State of Louisiana
Department of Health and Hospitals
Office of the Secretary

Re: Letter of Intent/Clarification – Sunning or Tanning Shelves for Public Pools

Re: Letter of Intent/Clarification – Sunning / Tanning Shelf

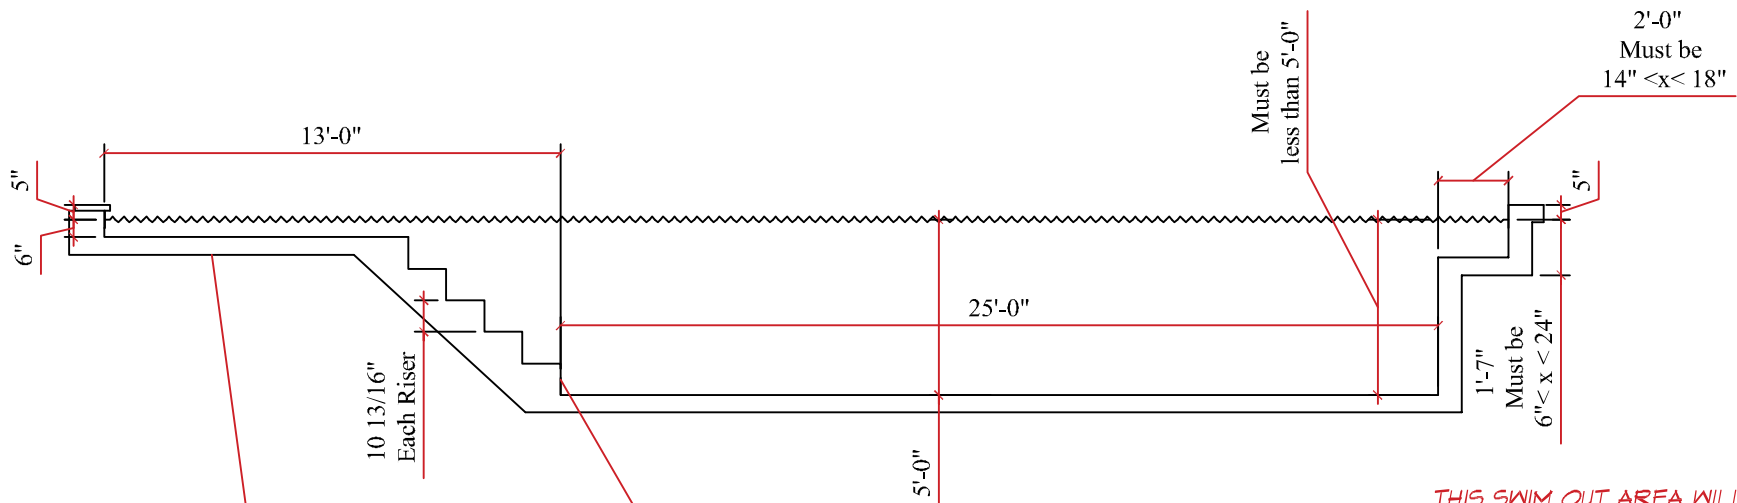
THE CODE STATES THAT: Risers at the centerline of the treads shall have a maximum uniform height of 12 inches, with the bottom riser height allowed to vary plus or minus 2 inches from the uniform riser height.

LAST RISER VARIES FROM
10-13/16" -2" TO +2"

THIS SWIM OUT AREA WILL BE CONSIDERED
AN UNDERWATER SEAT BENCH. THIS WILL
BE ALLOWED UNDER A WAIVER WHEN THE
REQUIREMENTS ARE MET : SEE VARIANCE
CRITERIA

Variance Criteria

1. Underwater seat benches shall only be allowed areas of the pool that are less than five feet deep.
2. Underwater seats shall not project into swim lanes.

3. The minimum and maximum water depth over the bench seat shall be 6 inches and 20 inches respectively.
4. Underwater seat benches shall have a seat depth of 14 to 18 inches projecting from the pool wall to the front edge of the seat or may be recessed from the main body of the pool a maximum of 36 inches. If recessed, the seat bench shall be a maximum of 18 inches wide with the remaining space for leg room.

5. A permanent colored band of dark, contrasting and slip-resistant tile shall be installed at the front edge of the seat extending two inches on the horizontal and vertical surface. The stripe shall be plainly visible to persons on the pool deck. Vinyl liner, stainless steel, and fiberglass pools may use other material for the bench edge marking provided the material is permanently secured, dark in color, non-fading, and slip resistant.

6. The underwater seat bench's front edge shall be rounded and have a minimum radius of one inch.
7. Underwater seats and benches shall not be used as the required entry/exit access unless they are in conjunction with pool steps.

8. If the underwater seat bench is constructed in conjunction with pool steps then a handrail must be installed in compliance with such requirements as required in the LAC Title 51 Part XXIV (Swimming Pools).
